CHANGE 2

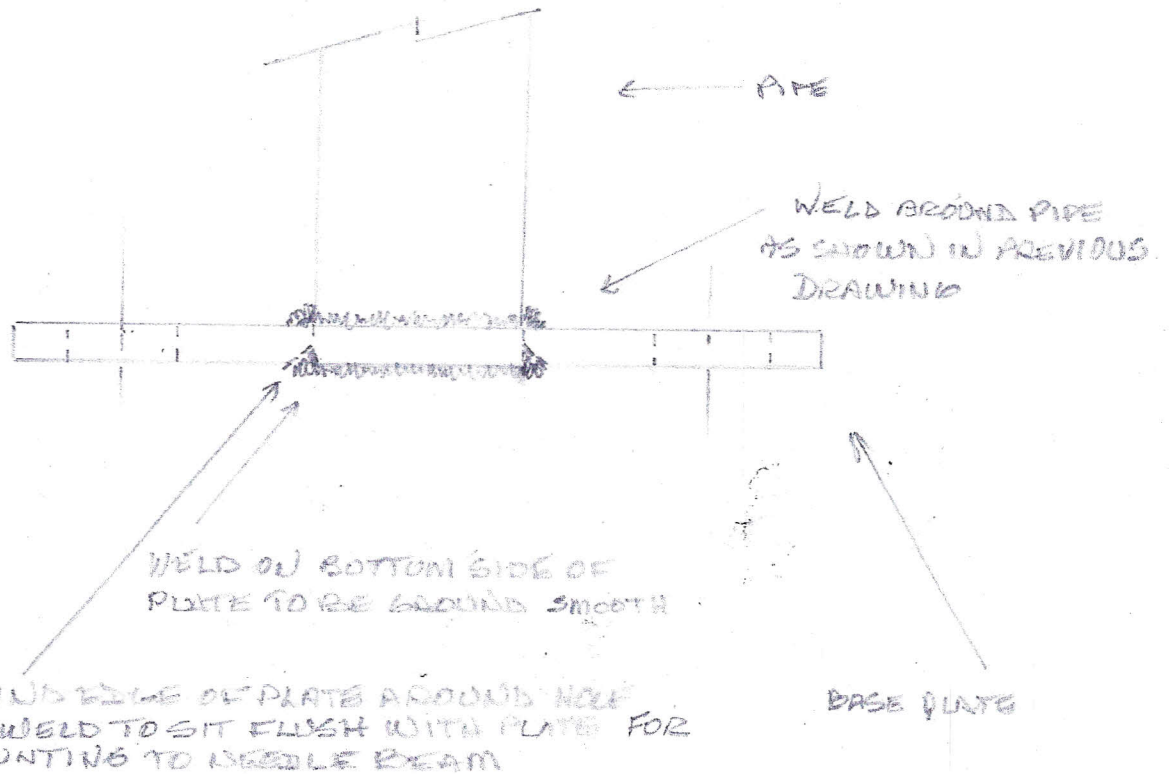
PIPE FOR POST TO GO THROUGH BASE PLATE
AND WELDED ON BOTH SIDES OF PLATE

REMEMBER TO ADD $\frac{3}{8}$ TO POST LENGTH
